PG&E Letter DIL-03-011

Docket No. 72-26
Diablo Canyon Independent Spent Fuel Storage Installation
Response to NRC Request for Additional Information Regarding Cask Transporter
Lateral Restraints for the Diablo Canyon ISFSI (TAC No. L23399)

**PG&E Response to NRC Request for Additional Information
Regarding Cask Transporter Lateral Restraints
When the Transporter is Positioned Over the CTF**

SAFETY ANALYSIS REPORT
DIABLO CANYON ISFSI
FIGURE 5.1-1 (3 of 3)
OPERATION SEQUENCE FLOWCHART FOR CASK SYSTEM LOADING, SEALING, TESTING, AND STORAGE

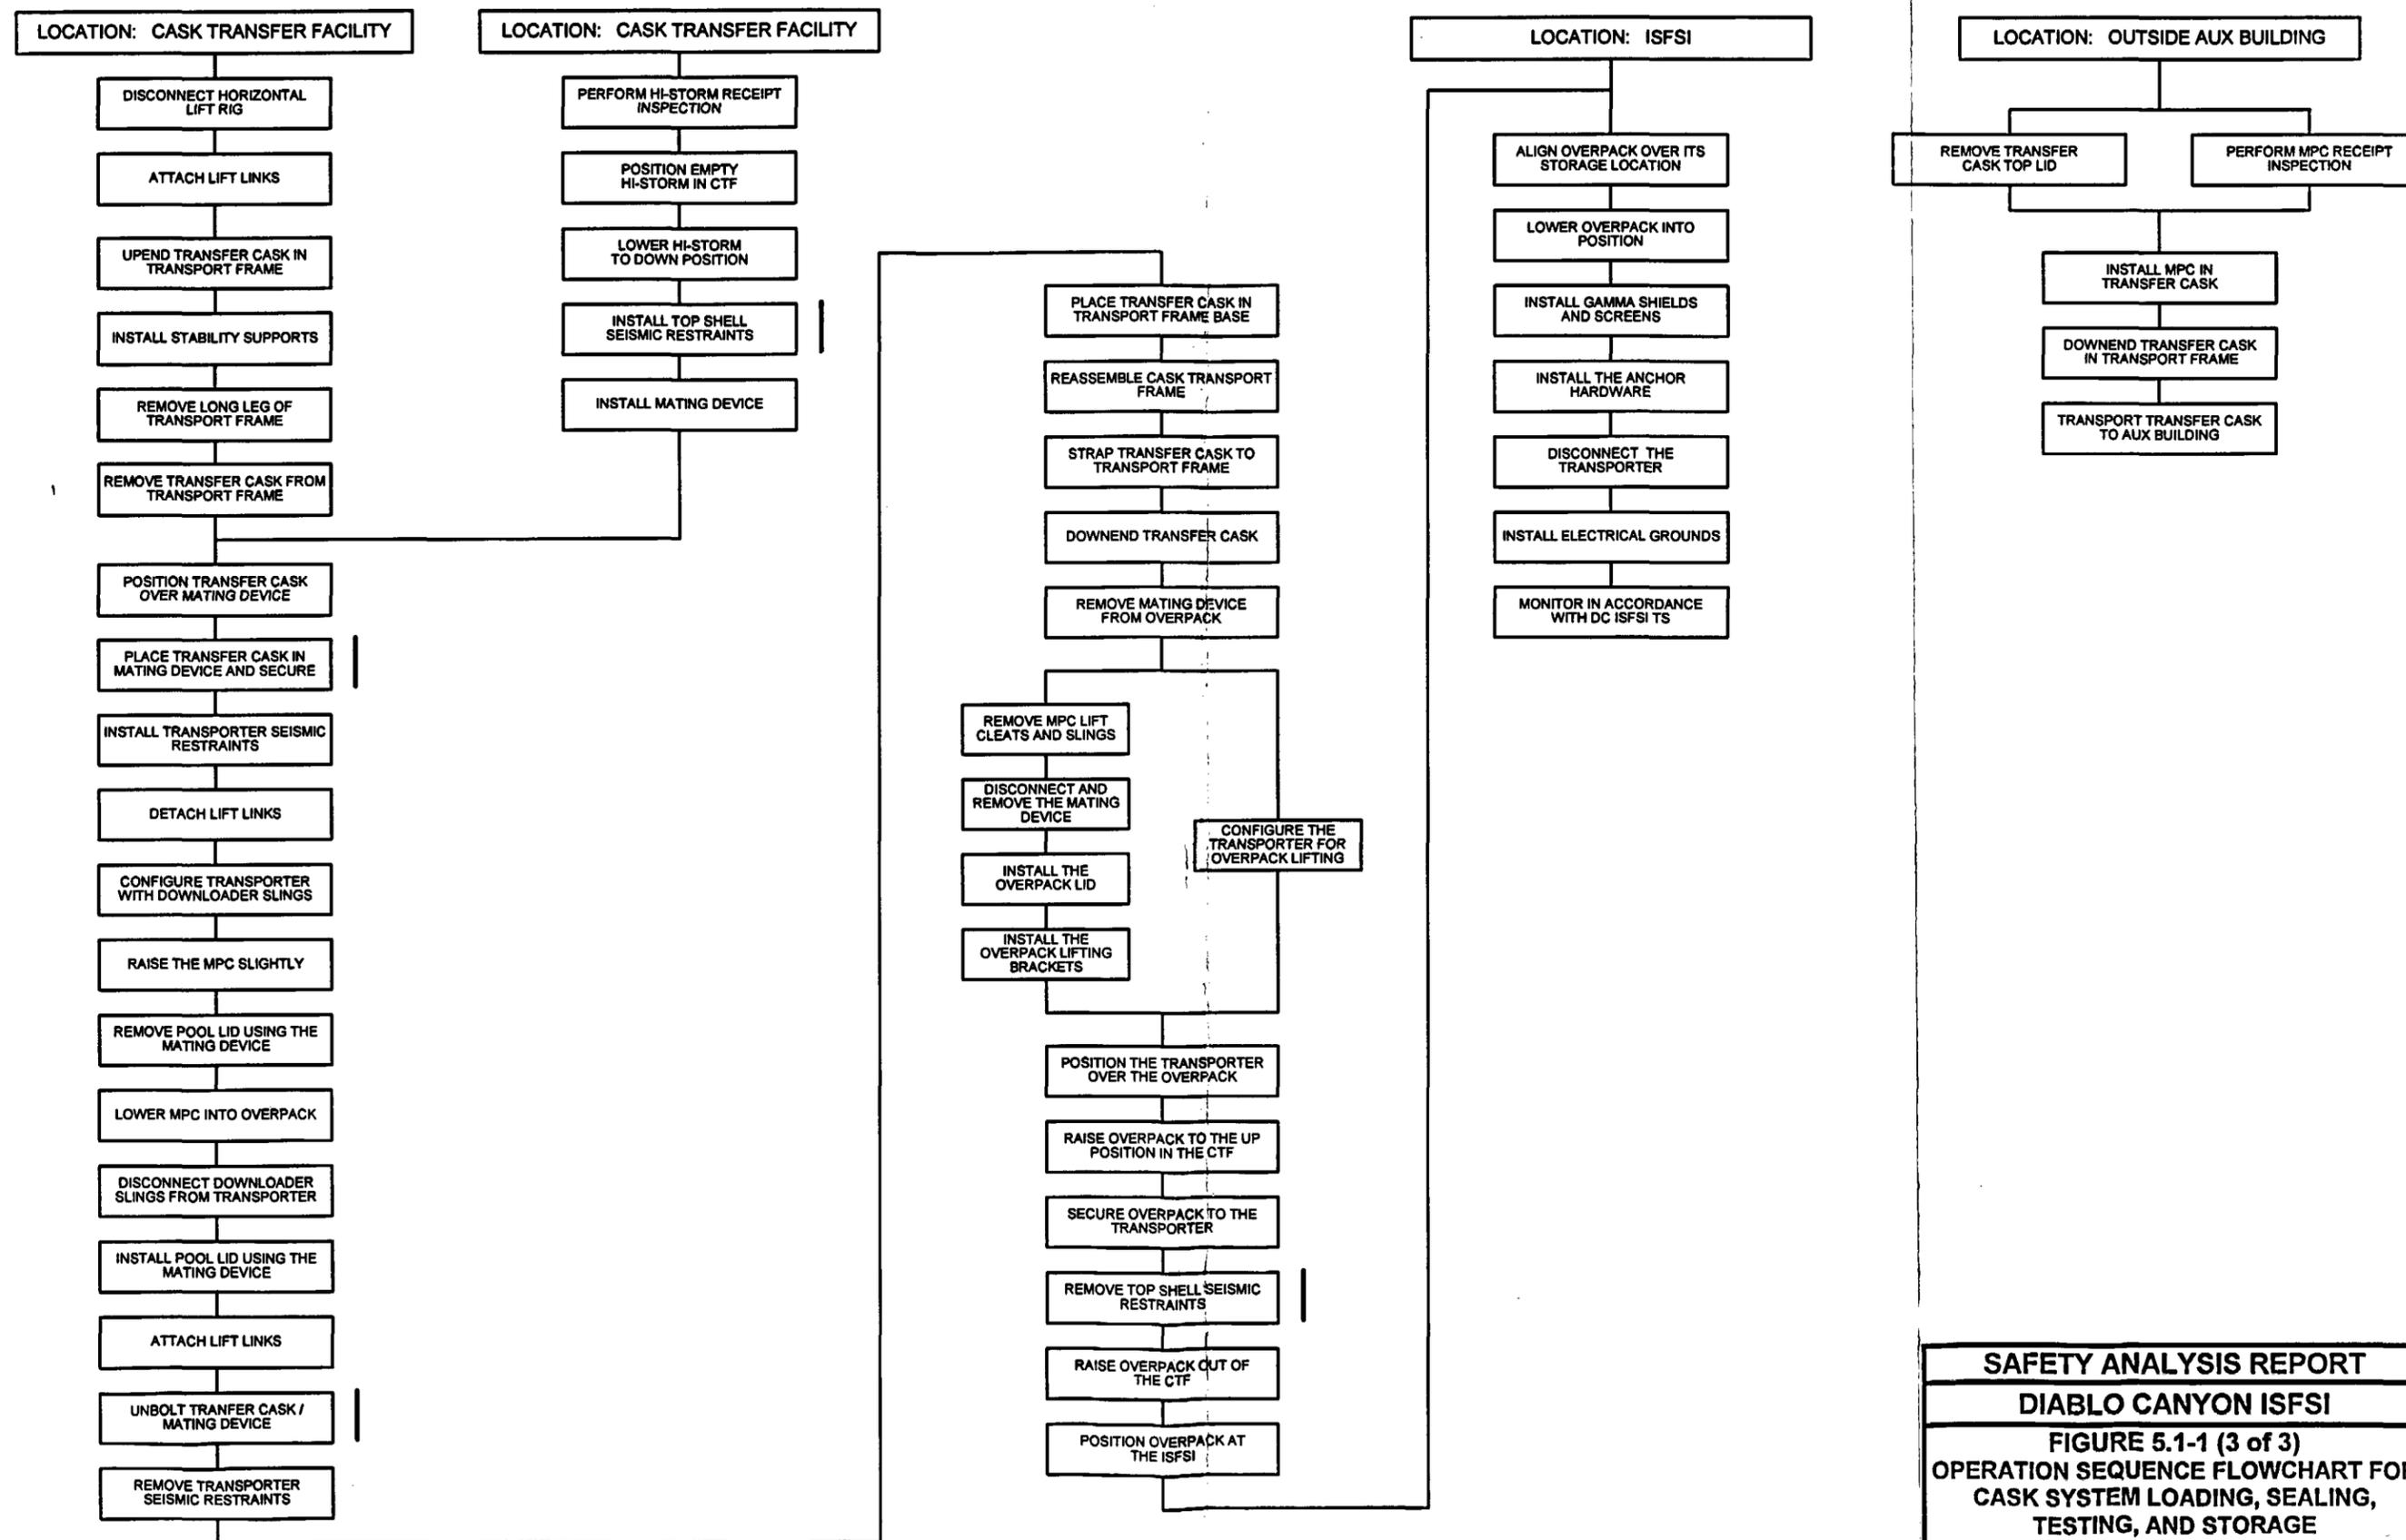
In a recent telephone call, PG&E staff indicated that the design of the cask transporter lateral restraints did not need to account for the weight of a loaded transfer cask, or loaded storage cask. For the specific configurations in question during MPC transfer at the CTF, PG&E indicated that the transporter is not relied upon to support these loads, except for very brief periods. The NRC staff requests that PG&E provide estimates of the brief time periods that the transporter is positioned over the CTF and is supporting: 1) the MPC as it is lowered into the overpack, and 2) the loaded HI-STORM 100 SA as it is raised off the CTF lift platform and out of the CTF. We understand that you consider the probability of an earthquake occurring while in either of these configurations to be so small as to make these events non-credible. This information is necessary for the staff to make its finding.

Revised Figures 5.1-1 (Sheet 3 of 3) and 5.1-2 (Sheet 1 of 2) are contained in Enclosure 2 with information added regarding the top shell seismic restraint installation and removal and the mating device. Also, in revised Figure 5.1-2 (1/2), under Cask Transfer Facility, the steps, "Remove Pool Lid Using the Mating Device," and "Connect Downloader Slings to Transporter," were reversed to show the correct order of these operations. Changes to the figures in Enclosure 2 are shown with side bars. PG&E will incorporate these figures into Amendment 2 of the FSAR, Section 5.1, which will be submitted to the NRC under separate cover. The revised figures will also be included in Section 5.1 of the ISFSI FSAR that will be submitted to the NRC within 90 days of the issuance of the ISFSI license.
